Final Technical Plan
July 1988

LITIGATION TECHNICAL SUPPORT AND SERVICES

Rocky Mountain Arsenal

Offpost Remedial Investigation/Feasibility Study

Figure A-9
DCPD ASSESSMENT RMA OFFPOST FIRST
QUARTER SAMPLING OF WELLS

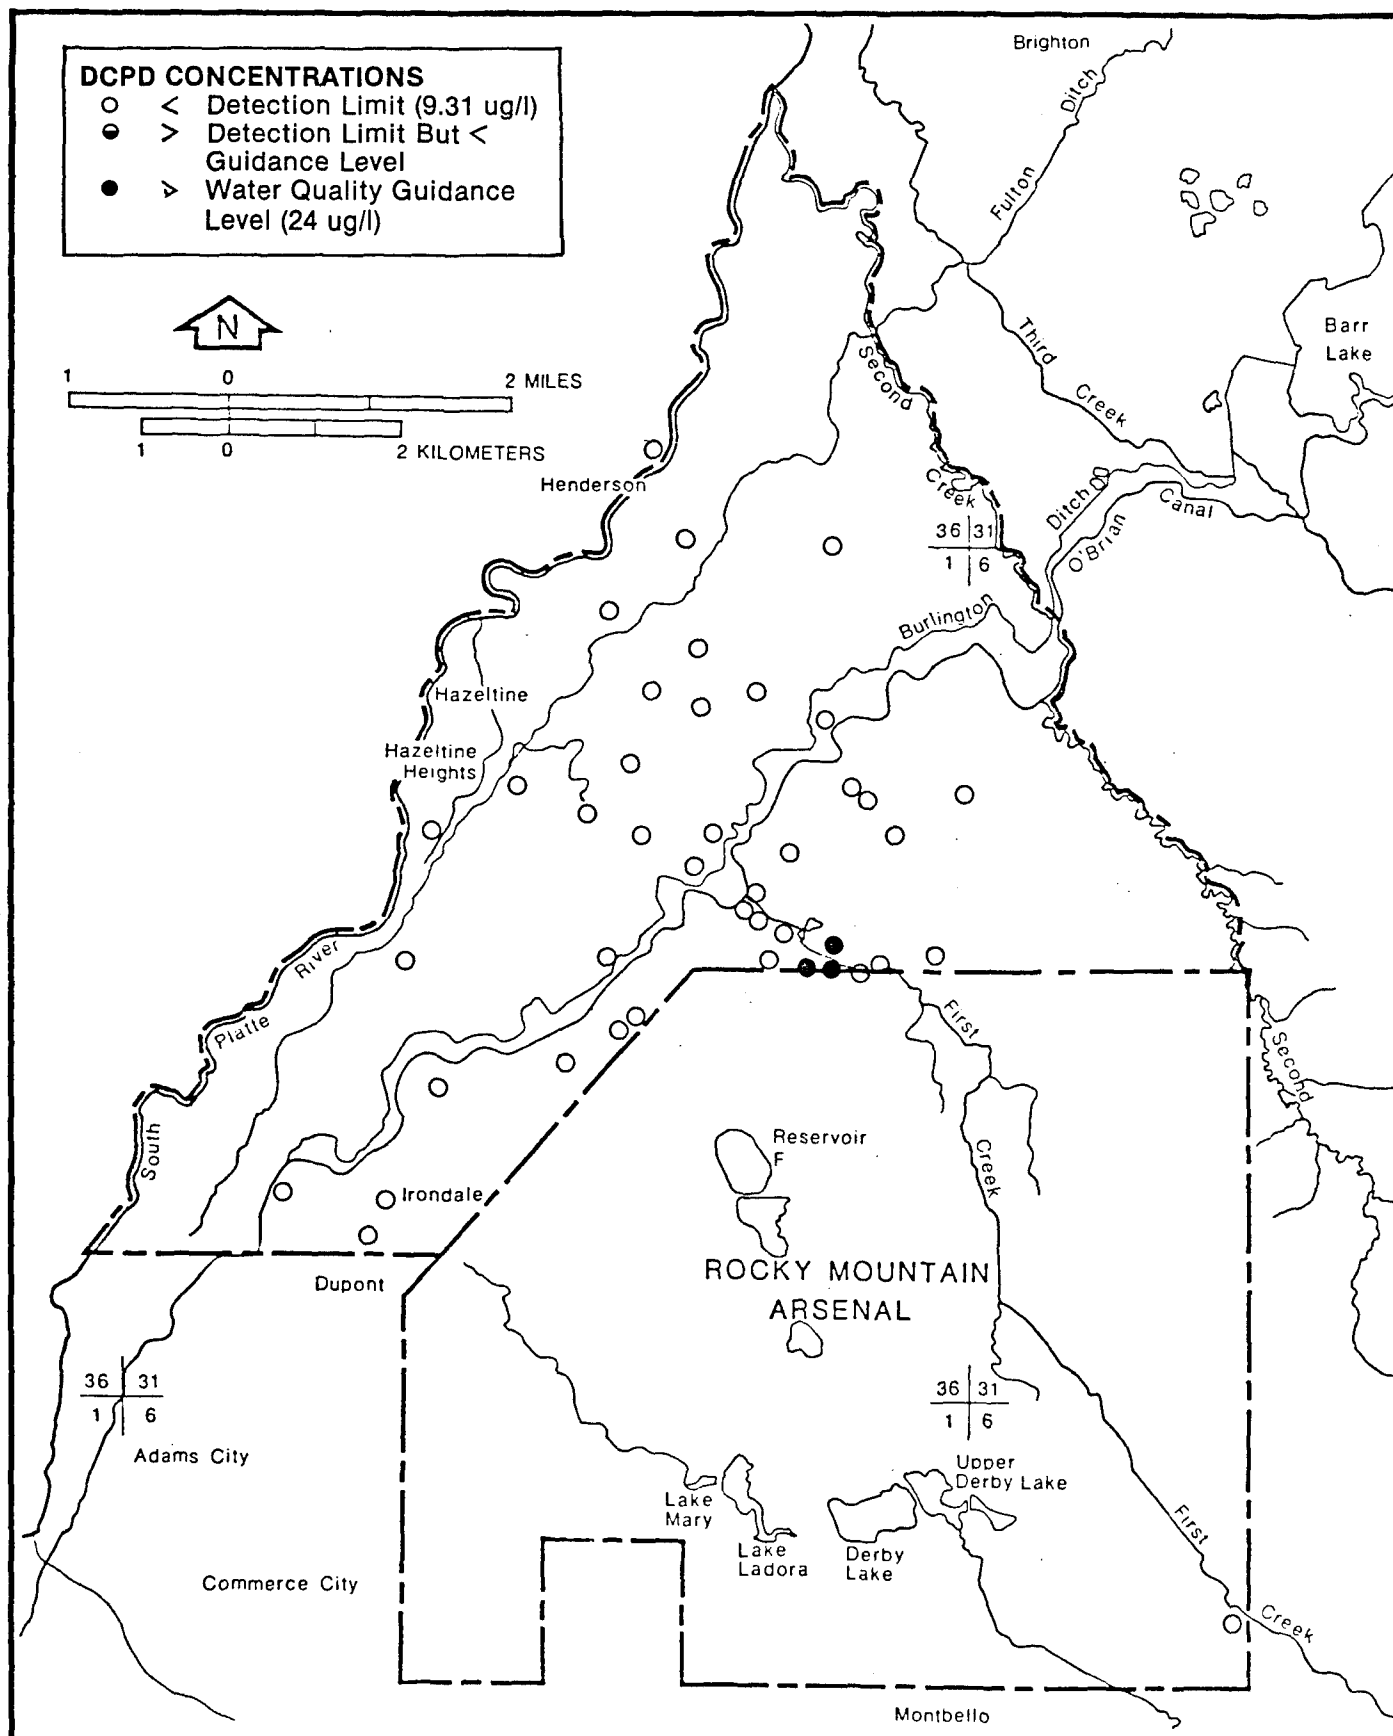
Comment 4:
Figure 1.4-1,
1.4-2, A-1 to A-9

Figure 2.4-9
SCHEMATIC DRAWING OF A
TYPICAL CLUSTER WELL
INSTALLATION

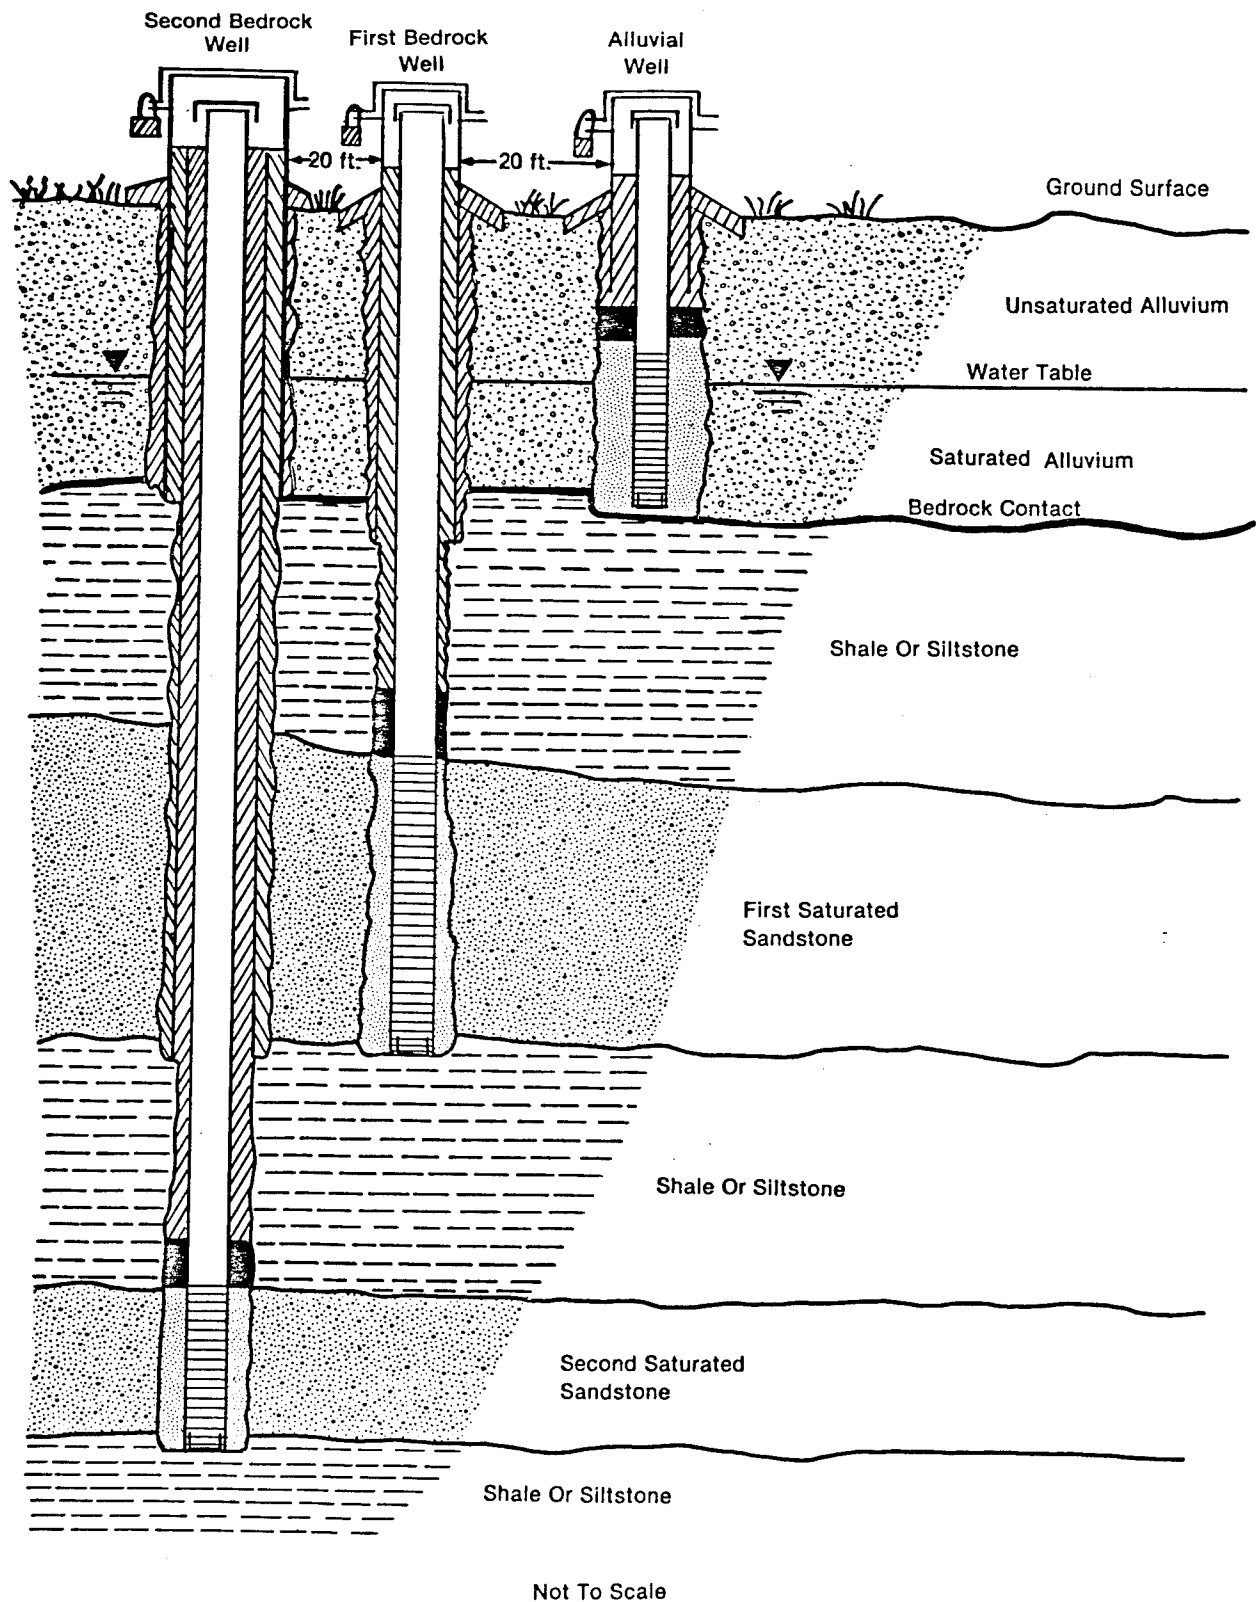
What is installed at the bottom of the casings in these wells? Are they capped? The screened interval should be labeled as such. Why are the cluster wells proposed to be 20 feet apart in Figure 2.4-9?
